CORRIGENDUM- 01

PROJECT	:	4 X 225 MW Arun-3 HEP, Nepal
PACKAGE	:	HVAC for Hydro
ENQUIRY NO	:	PE/PG/ARN/E-6566/2020 Dated 09.12.2020
SUBJECT	:	PRE-BID CLARIFICATION + DUE DATE EXTENSION

Arun-3-Hydro Electric Project-Nepal(4X225 MW) - PRE BID CLARIFICATION SCHEDULE		Specification No : PE-TS-437-571-11000-A-A001(Rev 00)		
		Section I		
		Rev No 00		Date : 24.12.20
Total no of sheets :1				
PRE BID CLARIFICATION SCHEDULE- HVAC System for Hydro				
SI No	Section/ Clause/ Page No	Staement of the referred Clause	Clarification Required	BHEL Reply
1	Page 49 of 470	Standard Electrical scope between BHEL and Vendor, Package : Electric Hoist for AC Ventilation	The contents of the page are not fully displayed. Hence provided a fresh page	Refer Amendment no. 1
2	Vol-II B Sec D -Page 417 of 470	Insulation Data Sheet	Please confirm the finish of insulation for the Ducts in Air conditioning system(Item SI No B-7 of Annexure I of unpriced BOQ)	Finish of insulation shall be as per clause 25.5.9 of chapter 25 (page 67-68 of 470) under sub section C2-A and other relevent clauses of technical specifications.

HVAC FOR HYDRO 4X225 MW ARUN-3 HEP	SPECIFICATION NO. PE-TS-437-571- 11000-A-A001
		AMMENDMENT

TITLE ELECTRICAL LAYOUT PLAN AND SECTION
OF 4x225MW OF ARUN-3 HEP

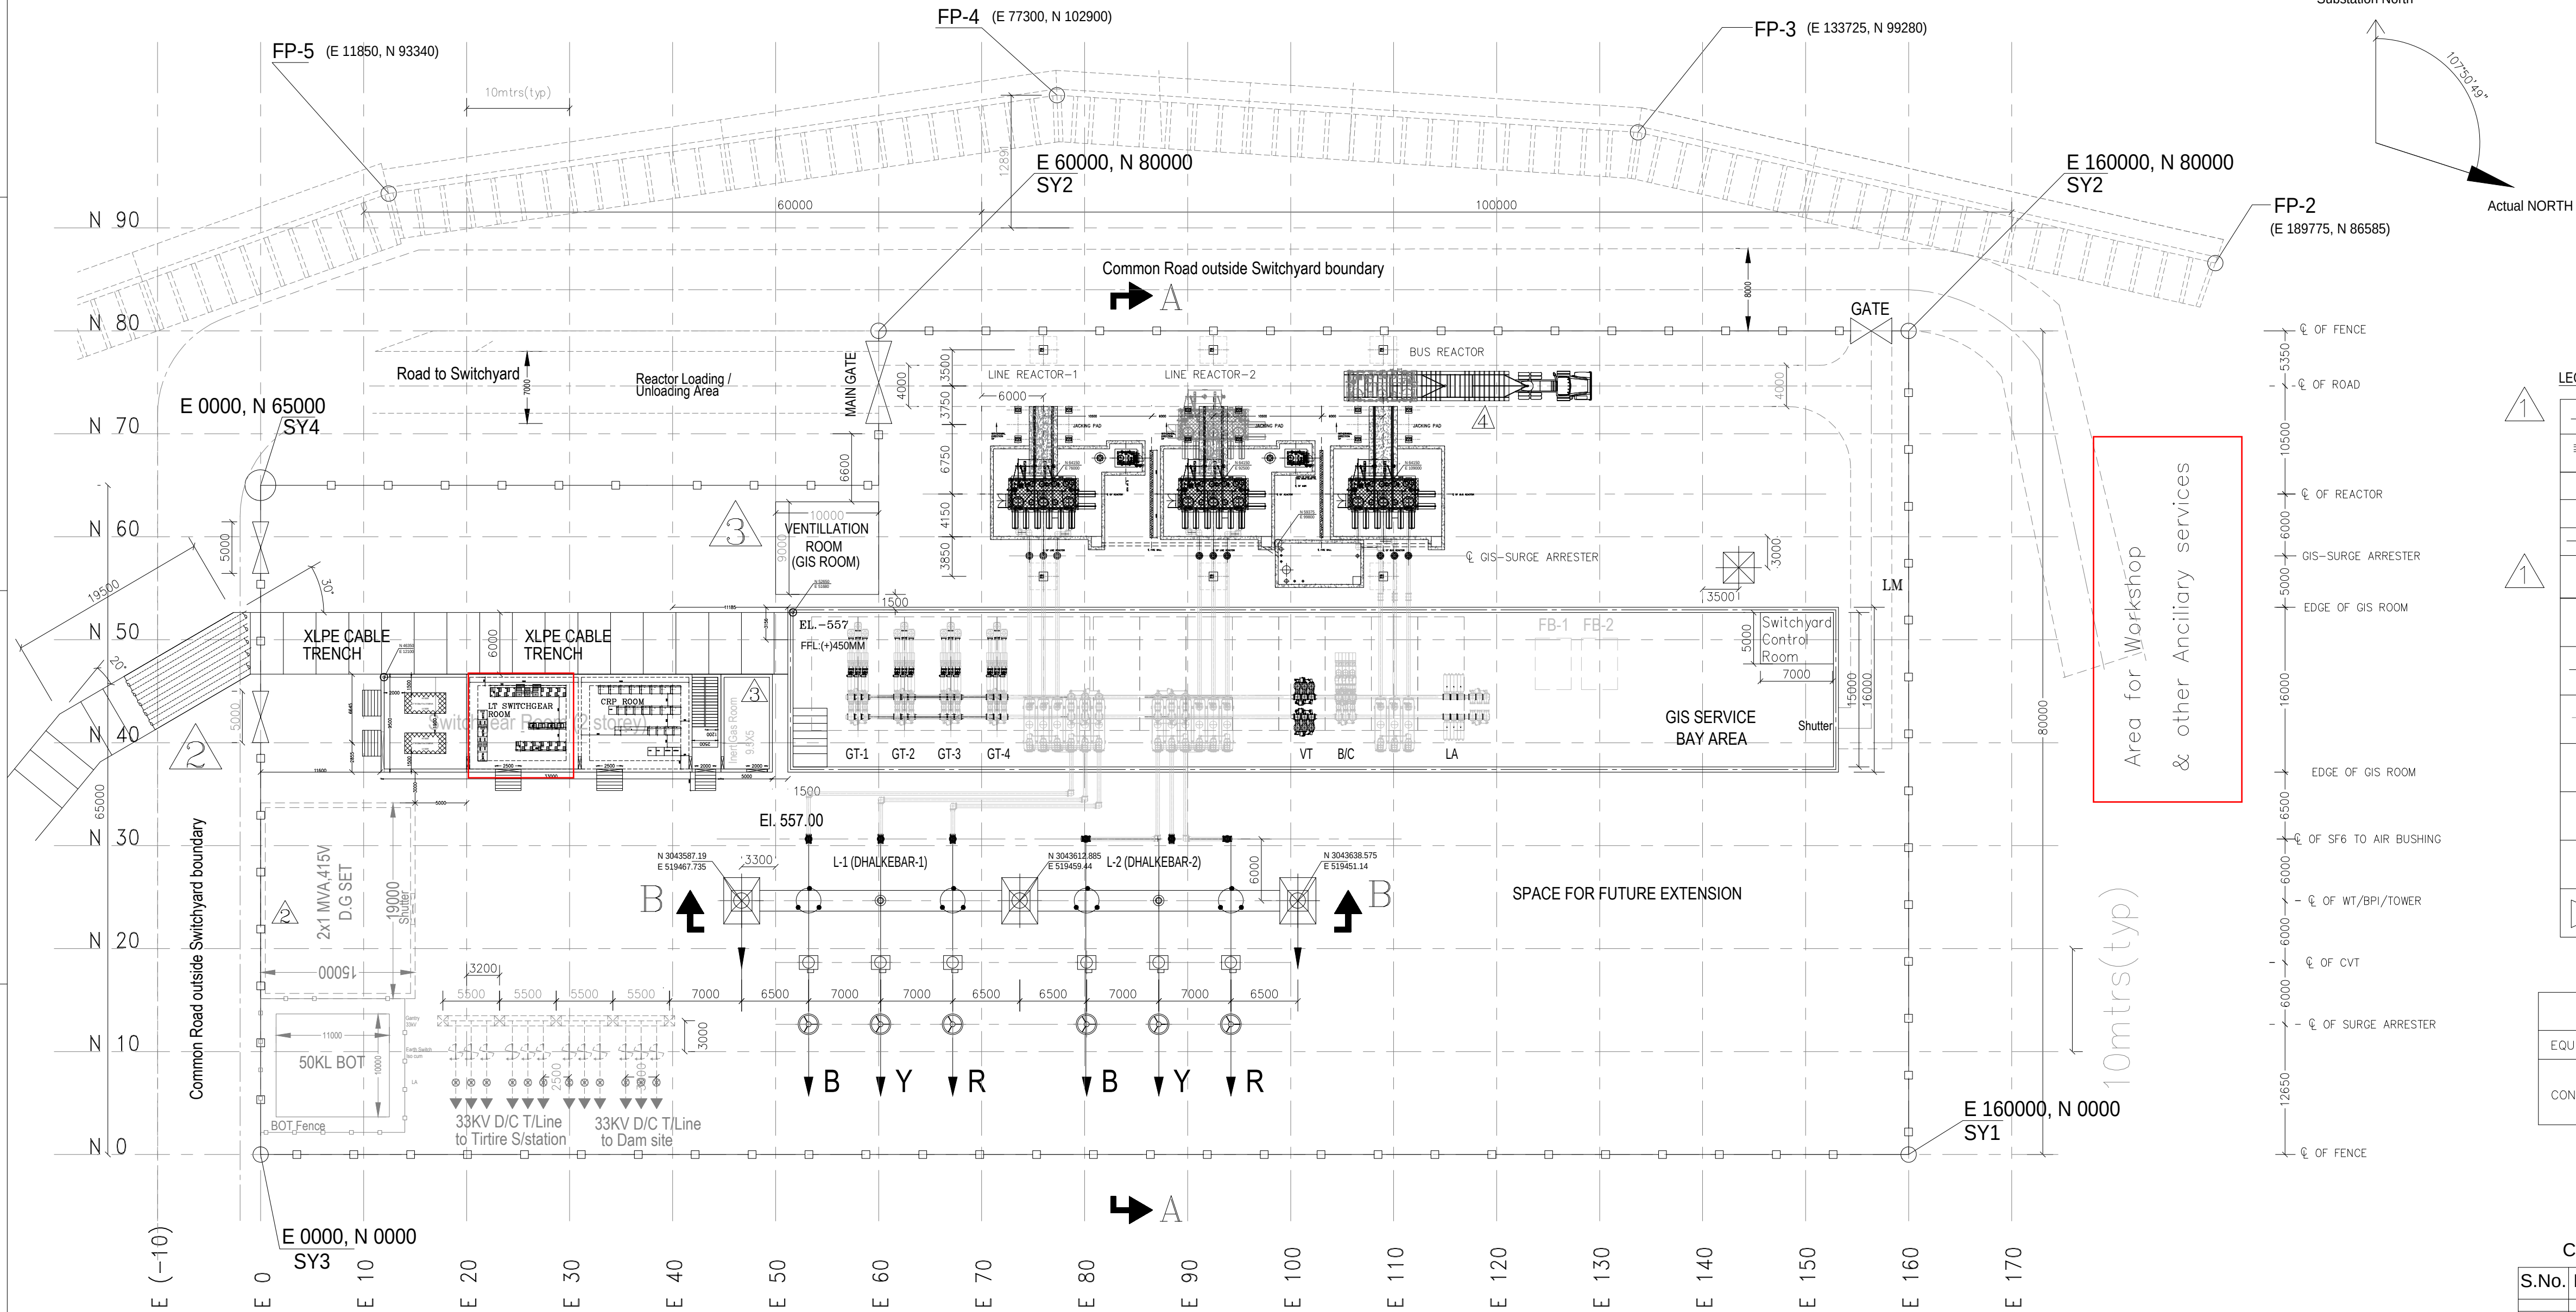
4	Section-II, Sub-section-6, Page 466 of 470 of Technical specifications	Layout of Mechanical Workshop near switchyard area	Mechanical workshop is standalone room located adjacent to Switchyard area. Switchyard area layout drawing showing location of Mechanical Workshop and Electrical scheme indicating location of source of Power supply for HVAC equipment for Mechanical workshop is attached.
5	Unpriced BOQ -Item No.A- 7 Of Annexure-I	Cabinet type Centrifugal Fans	Housing of Cabinet type centrifugal fans shall be as per manufacturer standard subject to approval of end user during detailed engineering. For all other details bidder to follow technical specifications.
